UNITED STATES PATENT AND TRADEMARK OFFICE

Office Action Summary	Application No. 10/540,232	Applicant(s) WURM ET AL.	
	Examiner BRYAN D. RIPA	Art Unit 1795

DETAILED ACTION

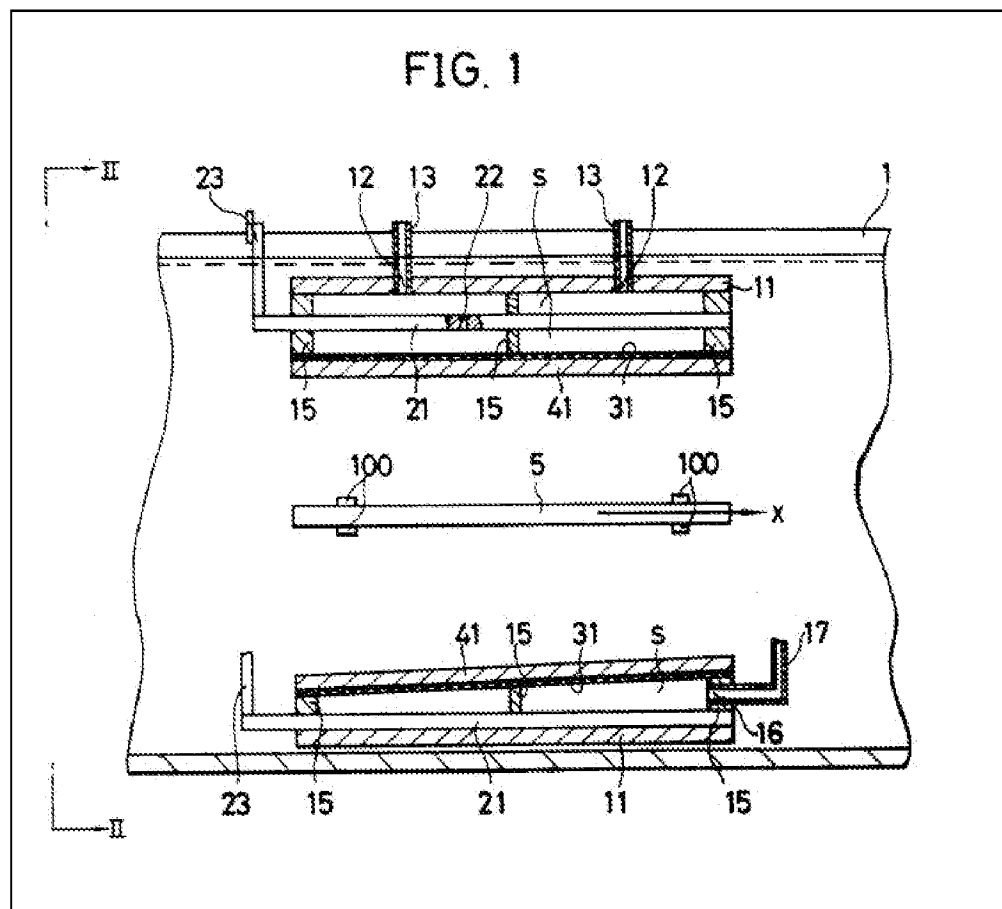
Regarding claim 1, USUDA teaches an anode for electroplating (see generally col. 2 line 57-col. 3 line 7; see also figures 1 and 4), which comprises an anode base and a shield (see insoluble plate electrode 21 as the anode base and diaphragm 31, rib member 41 and spacer 15 forming a shield covering the anode), and wherein the shield is attached to the anode base at a distance from it (see figure 1 depicting rib member 31 and diaphragm 31 attached to insoluble plate electrode 21 at a distance from it) and which reduces material transport to and from the anode base (see figure 1 showing diaphragm 31, rib member 41 and spacer 15 acting to cover the bottom surface of the insoluble plate electrode 21 which would inherently act to reduce the material transport to and from the anode to at least some degree). See figure 1 below.

Regarding claim 10, USUDA as modified by KOVARSKY and YANG teaches the anode for electroplating in which the form of the shield and the arrangement and the distance of the shield from the anode base are such that the gas bubbles forming at the anode during electroplating are brought together (see figure 1 above; see also col. 4 lines 43-60 discussing the arrangement of the electrode such that gas bubbles are brought together as claimed).

- providing an anode base (see insoluble plate electrode 21);
- providing a shield attached to the anode base at a distance from the anode base (see diaphragm 31, rib member 41 and spacer 15 forming a shield covering the anode; see also figure 1 depicting rib member 41 and diaphragm 31 attached to insoluble plate electrode 21 at a distance from it);

- reducing material transport to and from the anode base through the action of the shield as a mechanical barrier (see figure 1 showing diaphragm 31, rib member 41 and spacer 15 acting to cover the bottom surface of the insoluble plate electrode 21 which would inherently act to reduce the material transport to and from the anode to at least some degree). See figure 1 below.

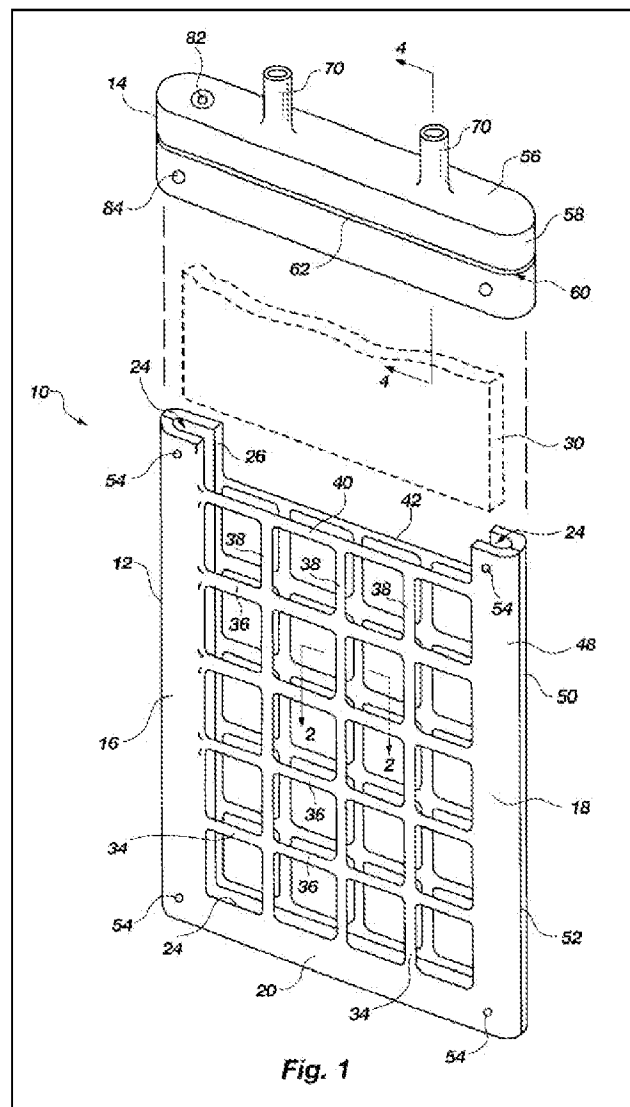
Regarding claims 9 and 27, while USUDA clearly teaches a space or gap between diaphragm 31 and rib members 41 and the insoluble plate electrode 21 (see figure 1), USUDA as modified by KOVARSKY and YANG fails to explicitly teach the

Consequently it would have been obvious to one of ordinary skill in the art based on USUDA that a gap would need to be present. Moreover, based on the teachings of SHINOHARA one of ordinary skill in the art would have appreciated the need to optimize the distance or spacing such that the bubbles are permitted sufficient space to form and be released so as to make there way to the degassing holes of USUDA.

Therefore it would have been obvious to one of ordinary skill in the art to either optimize the distance as claimed or to incorporate the teachings of SHINOHARA disclosing there being a spacing of between 1 to 15 mm between the diaphragm and the insoluble plate electrode.

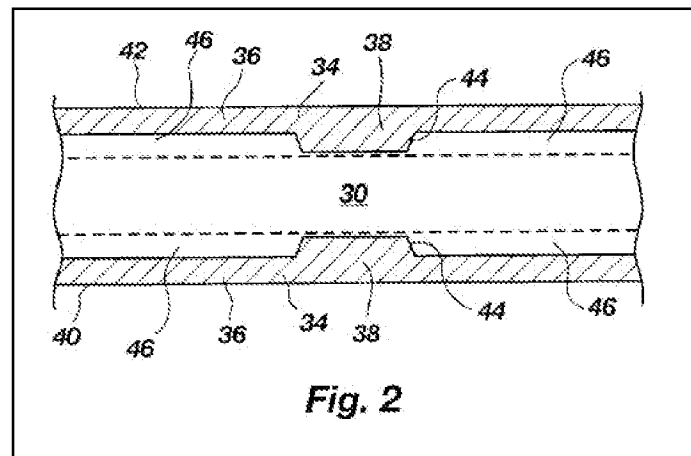
Regarding claim 1, DAY teaches an anode for electroplating (see generally col. 2 lines 25-36), which comprises an anode base and a shield (see anode 30 in figure 1

shown to go inside anode box 10), and wherein the shield is attached to the anode base at a distance from it (see figure 1) and which reduces material transport to and from the anode base (see horizontal and vertical spacers 36 and 38 acting to cover the surfaces of anode plate 30 which would inherently act to reduce the material transport to and from the anode to at least some degree) and wherein the shield is connected to the anode base in an electric current-conducting manner (see figure 2 depicting vertical spacer 38 touching anode plate 30 as boss 44). See figures 1 and 2 below.

Regarding claim 6, DAY as modified by KOVARSKY and YANG teaches the anode for electroplating in which the shield comprises one of a metal grid, an expanded metal and a perforated plate (see figure 1 of DAY depicting vertical and horizontal spacers comprising a grid; see also YANG as incorporated above in the rejection of claim 1 such that the anode box 10 would be made of titanium, i.e. a metal).

Regarding claim 10, DAY as modified by KOVARSKY and YANG teaches the anode for electroplating in which the form of the shield and the arrangement and the distance of the shield from the anode base are such that the gas bubbles forming at the anode during electroplating are brought together (see figure 1 above and gas vent 82; see also col. 2 lines 55-61).

- providing an anode base (see anode plate 30);
- providing a shield attached to the anode base at a distance from the anode base (see anode box 10 forming a shield covering anode plate 30; see also figure 2 depicting vertical spacers 38 attached to anode plate 30 and horizontal spacers 36 of anode box 10 at a distance from anode plate 30);

- wherein the shield is connected to the anode base in an electric current-conducting manner (see figure 2 depicting vertical spacer 38 touching anode plate 30 as boss 44);

Regarding claims 9 and 27, while DAY clearly teaches a space or gap between the anode box 10 and the anode plate 30 (see gap 46 in figure 2), DAY as modified by KOVARSKY and YANG fails to explicitly teach the anode for electroplating wherein the shield is at a distance of 0.01 to 100 mm from the anode base.
